JAFNPP

IMPROVED STANDARD TECHNICAL SPECIFICATIONS (ISTS) CONVERSION

ITS: 3.4.7

Residual Heat Removal (RHR) Shutdown Cooling
System - Hot Shutdown

Figure 3.6-1 Part 1 Reactor Vessel Pressure-Temperature Limits Through 24 EFY

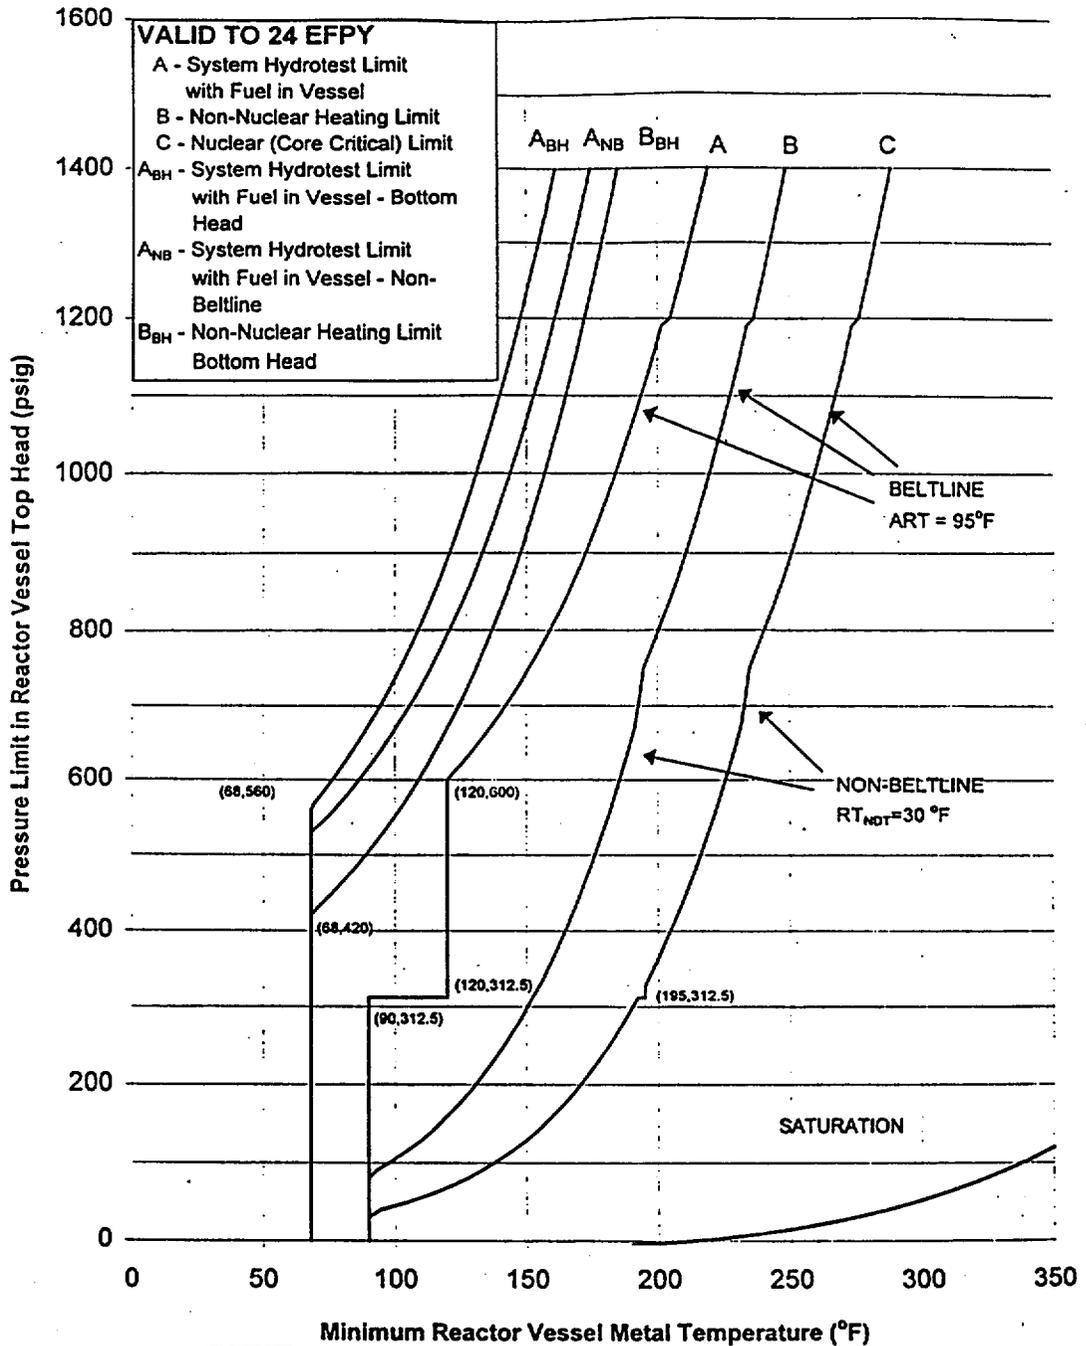
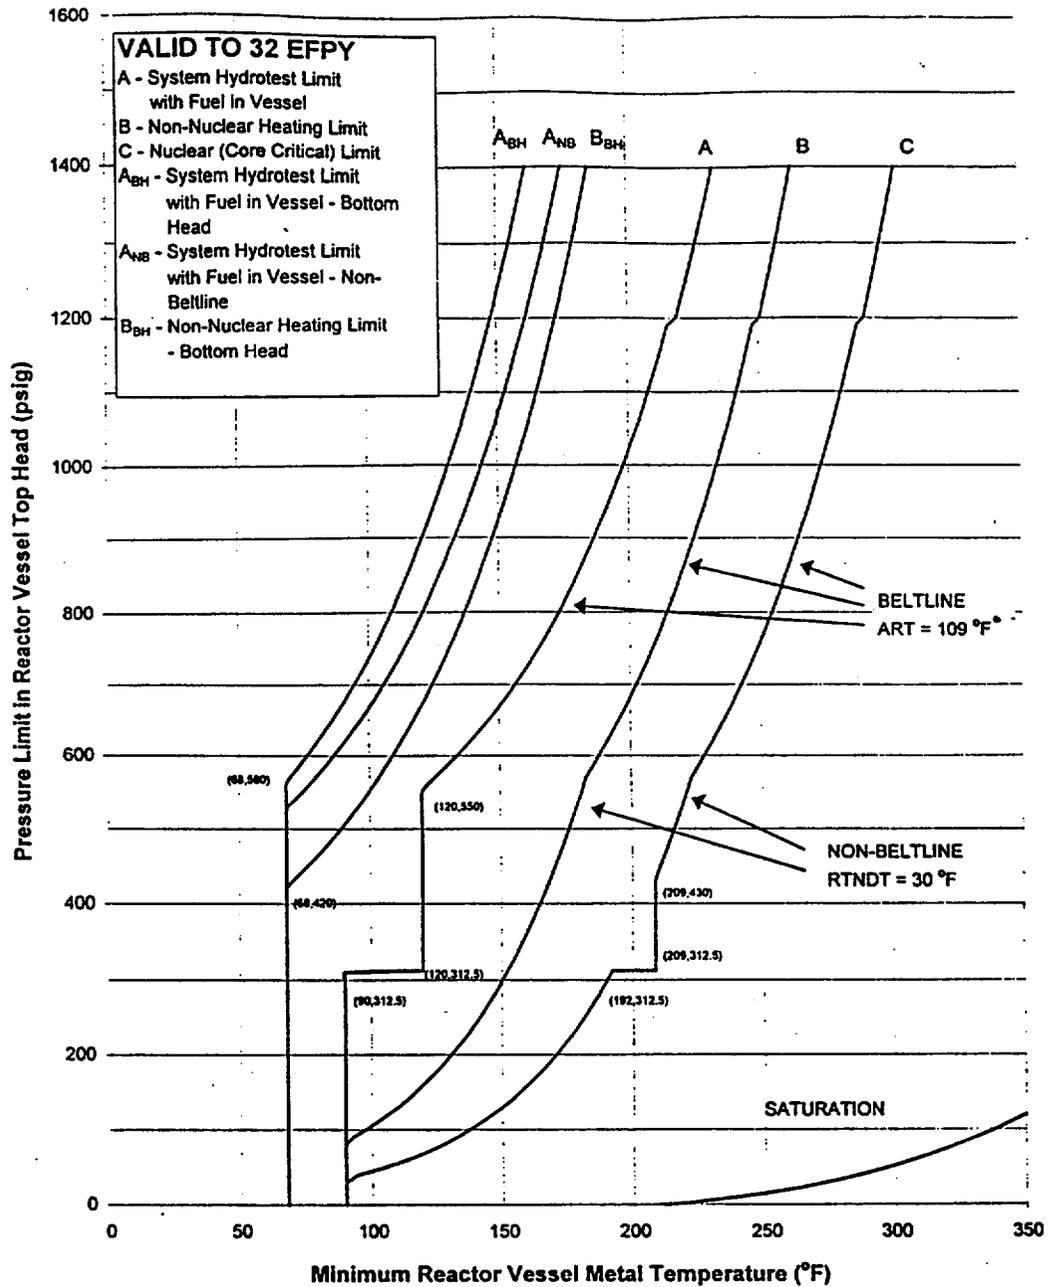
2. In-Service Hydrostatic and Leak Tests (A1)
During in-service hydrostatic or leak testing the Reactor Coolant System pressure and temperature shall be ~~on or to the right of curve A~~ shown in Figure 3.6.1 Part 1 or 2 for the flange and the beltline region, and ~~on or to the right of curve A_{nb}~~ for the non-beltline regions, and ~~on or to the right of curve A_{bh}~~ for the bottom head region. The maximum temperature change during any one hour period shall be:
(A1)
3.4.9-1 or 3.4.9-2

- LA4 Not used.
- LA5 The specific requirements in CTS 3.6.A.2, 3.6.A.3, and 3.6.A.4 that operation be on or to the right of the curves of Figure 3.6-1 Part 1 or 2 are proposed to be relocated to the Bases. These details are not necessary to ensure that P/T limits are met. The requirements to maintain the P/T limits in accordance with the Figures are still maintained in ITS 3.4.9 and SR 3.4.9.1. Therefore, the relocated requirements are not required to be in the ITS to provide adequate

Figure 3.4.9-1 (page 1 of 1)
Reactor Coolant System Pressure and
Temperature Limits through 24 Effective Full Power Years (EFPY)

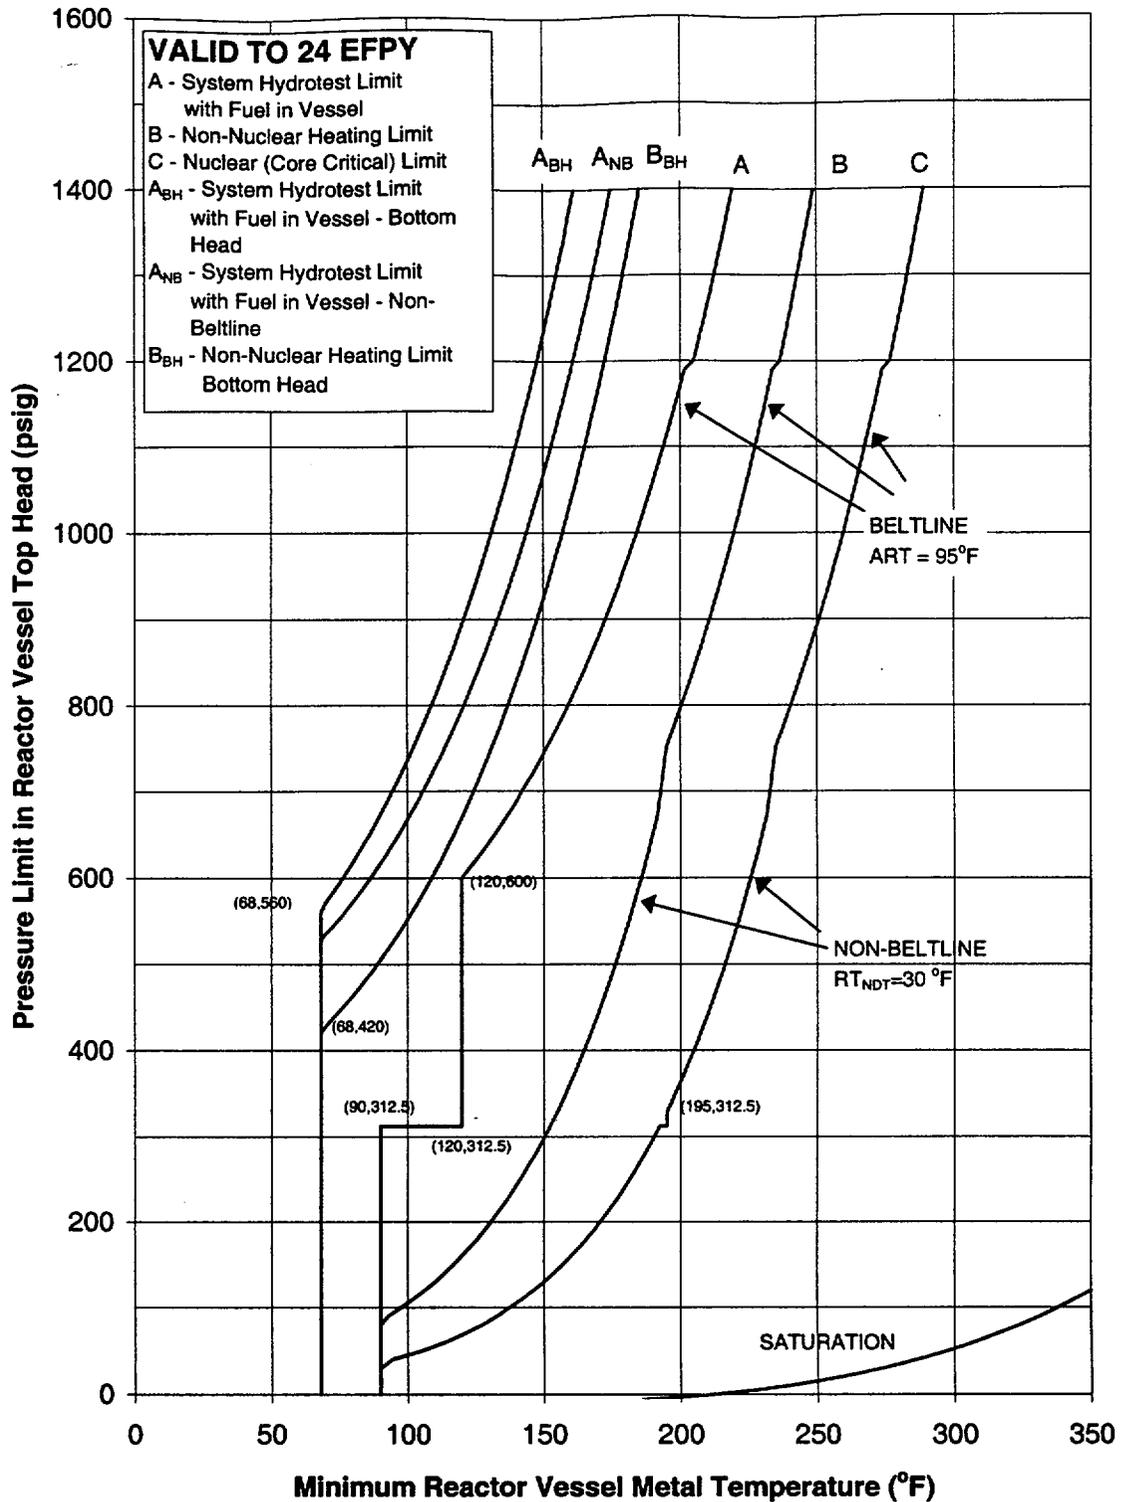
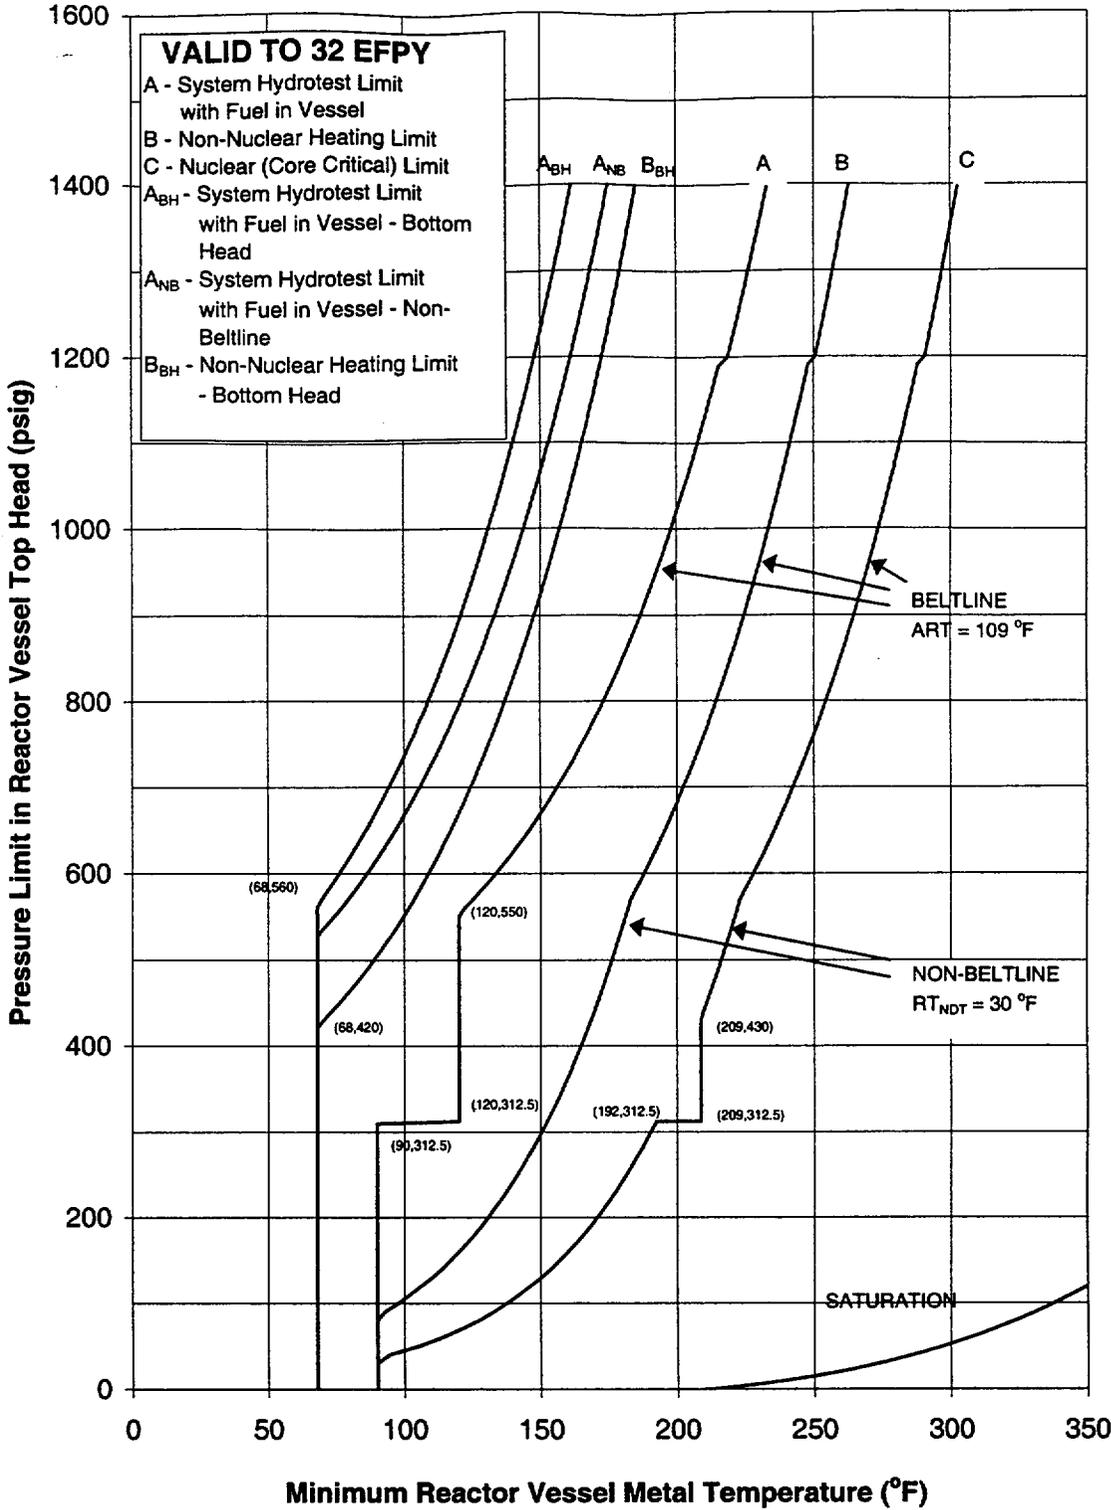
3.4.9-06 CTS 3.6.A.2, .3, .4 Figure 3.6-1 Bases

CTS 3.6.A.2, 3.6.A.3 and 3.6.A.4 specify being to the right of CTS Figure 3.6-1 curves A, B, and C respectively, which makes clear the safe area for operation. By implication the same applies (being to the right) of the curves on ITS Figure 3.4.9-1. ITS 3.4.9 including ITS Figure 3.4.9-1, which is exactly the same as CTS figure 3.6-1 Part 3, and ITS 3.4.9 Bases do not specify anywhere that the safe area relative to curve A, B, or C is to the right. ITS 3.4.9 simply requires maintaining pressure and temperature within limits.

Comment: State where in the LCO the limits are found. Additionally, provide clarification in ITS 3.4.9 Bases where the safe area relative to ITS Figure 3.4.9-1 curves A, B, and C is located.

1. As noted in response RAI 3.4.9-01, NUREG-1433, Revision 1, does not state where pressure and temperature limits are found beyond making reference to an external report. In contrast, FitzPatrick limits are incorporated directly into ITS 3.4.9, with specific limits identified or referenced as applicable. Each specific limit is identified in its respective surveillance. (See response RAI 3.4.9-01.)
2. A note will be added to ITS Figure 3.4.9-1 specifying that safe operation is on or to the right of curve A, B, or C, as appropriate.
